MEETING NOTICE
TUALATIN ARCHITECTURAL REVIEW BOARD
August 13, 2014, 6:30 PM
Addendum Item 4B
POLICE TRAINING ROOM
8650 SW TUALATIN RD
TUALATIN, OR 97062

River Ridge Apartment Complex Addendum

Addendum memo as a result from August 8, 2014 submittal from applicant. The applicant has provided documentation that meeting codes is feasible with the current proposal and conditions of approval. This additional information is attached for your reference.

L4.0

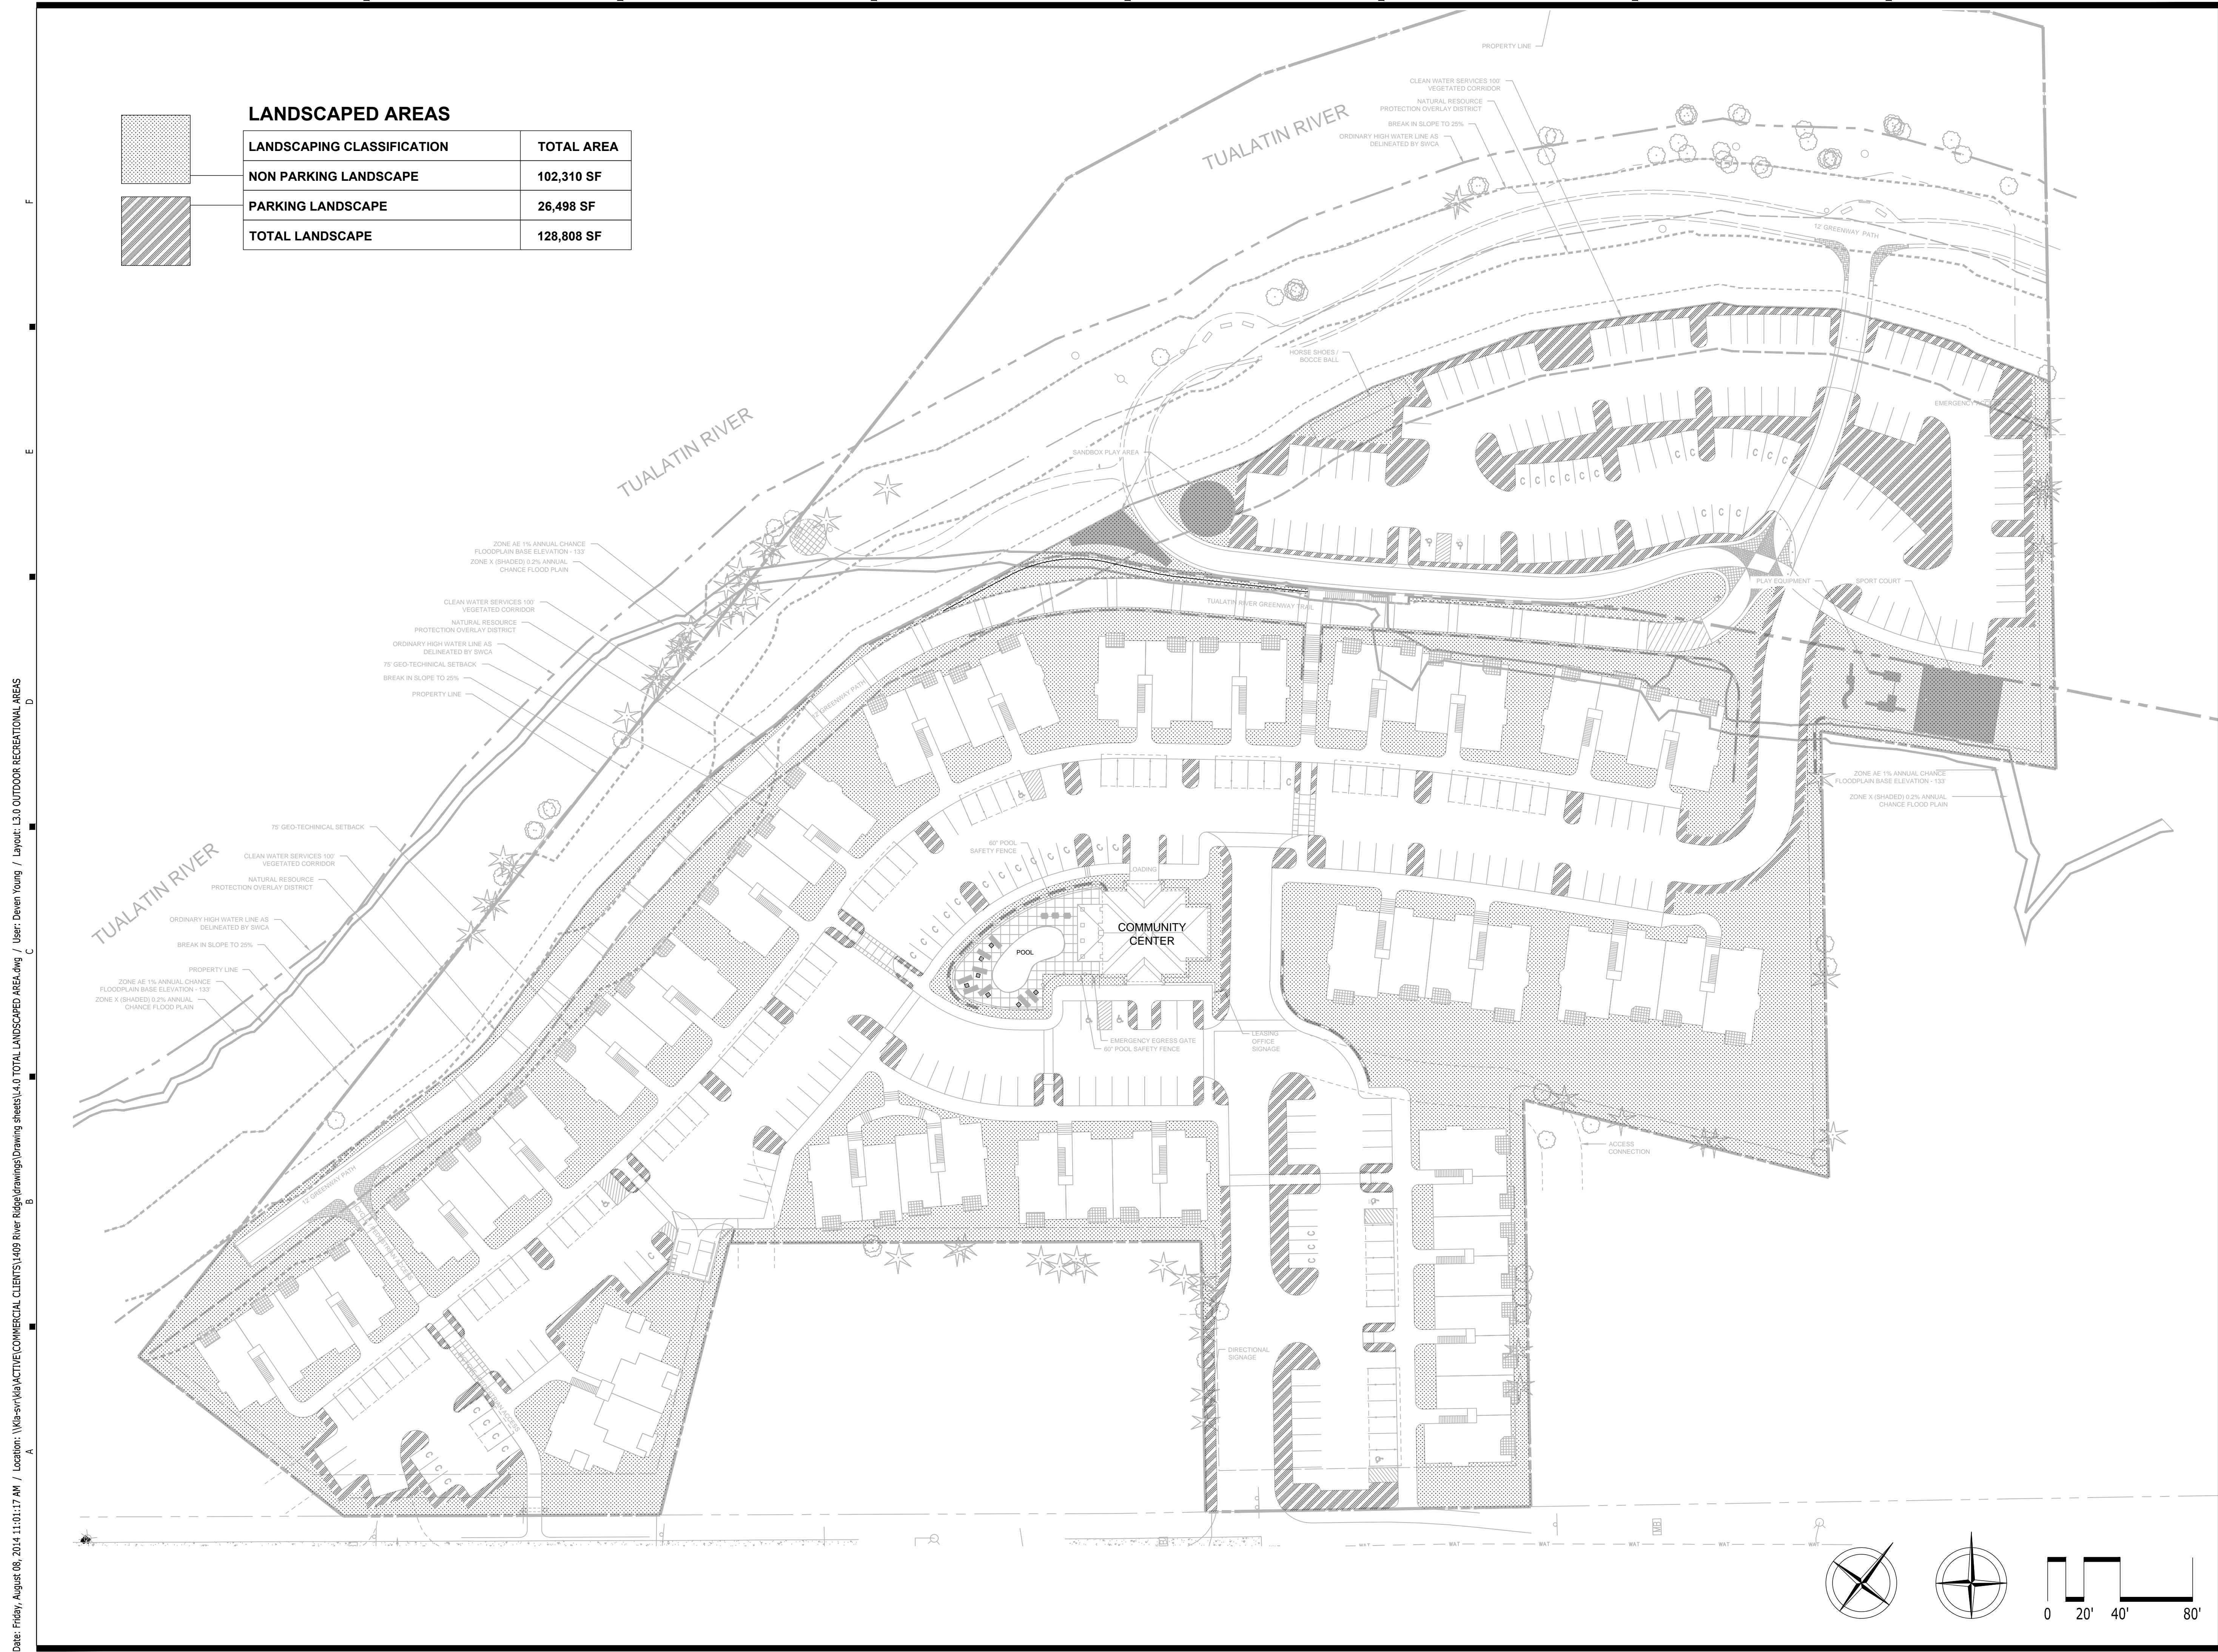
3. The third issue has also been resolved. Section 73.100(1) only requires that applicant provide 25% or 20% if the use is a conditional one. This apartment complex is allowed outright in the High Density Residential plan district, therefore no minimum landscaping is required. However, the applicant has shown that almost 25% of the site will be landscaped. Staff recommends conditioning the applicant to this proposal.

SK - 060
 Site Section Diagram - Location 'B'

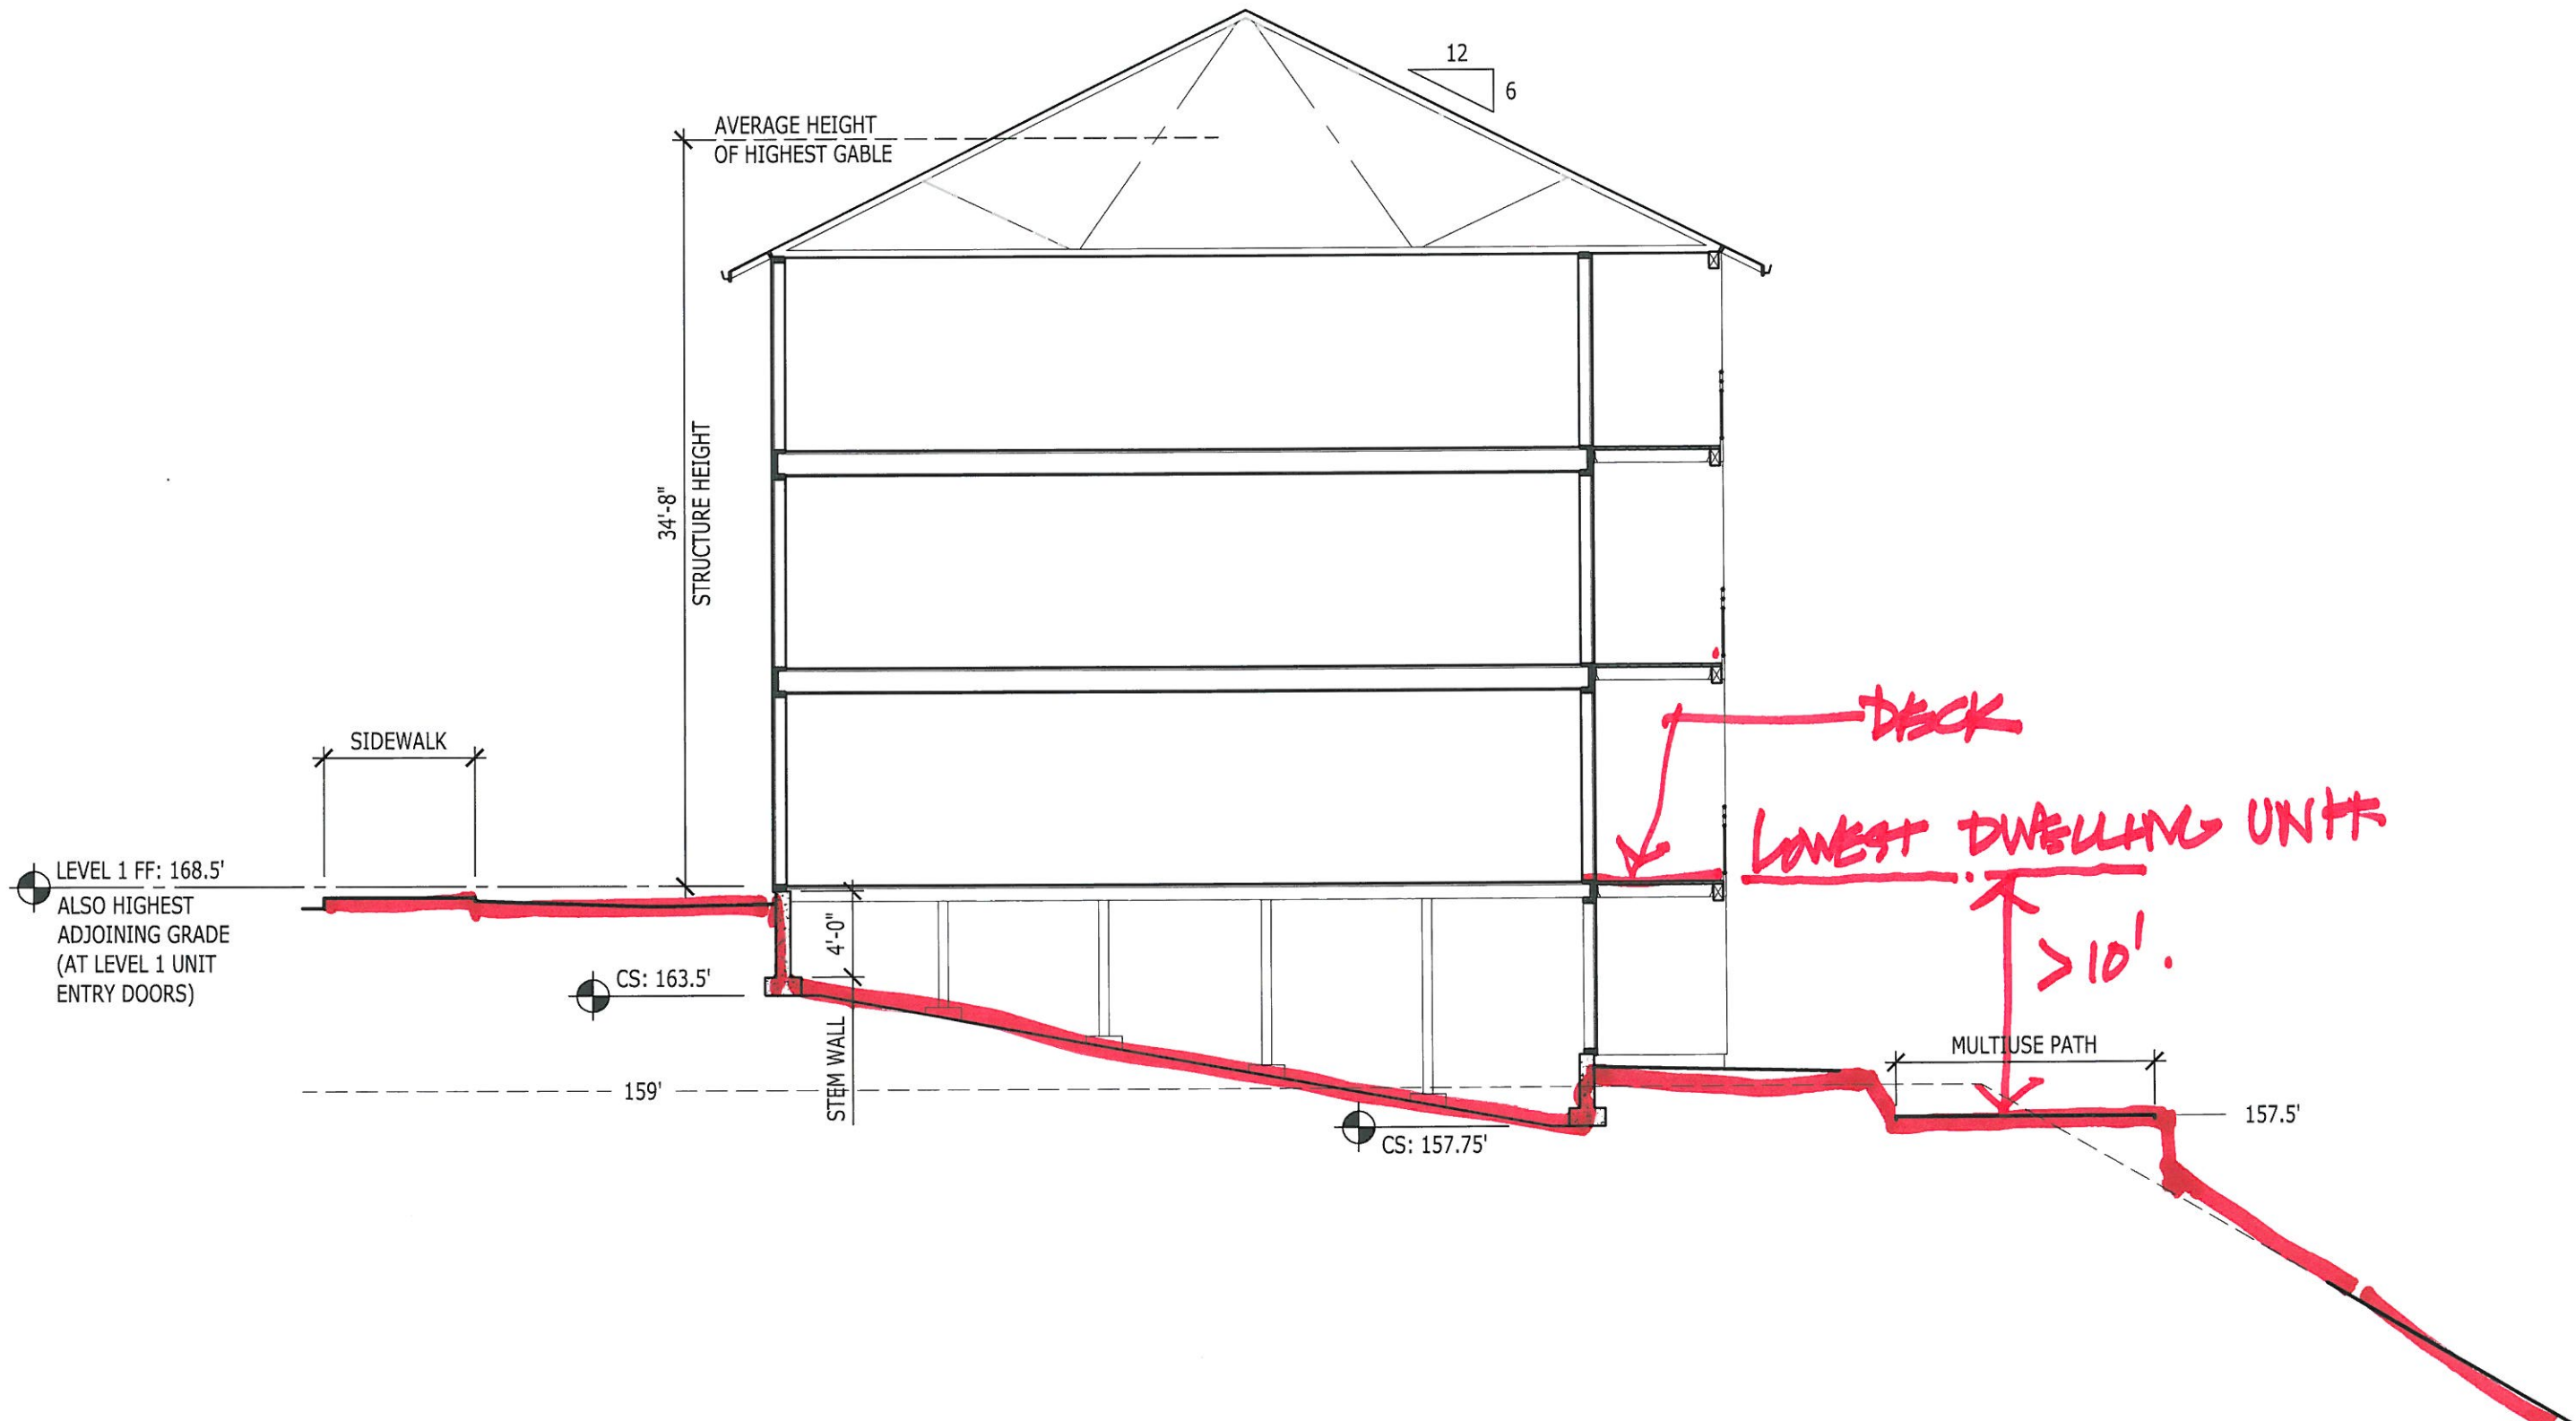
As designed, the ground floor units of buildings 2, 3 and 9 thru 15 have at grade concrete patios of 80 SF or more with 48 SF decks at upper floors. Buildings 4 thru 8 have 48 SF decks at all floor levels as the finished grade drops an average of 10 feet from the parking lot (ground floor building entrance) side to the view (Tualatin River) side where the buildings are in close proximity to the greenway path. This grade change puts the bottom floor significantly above the ground making construction of concrete patios prohibitive.
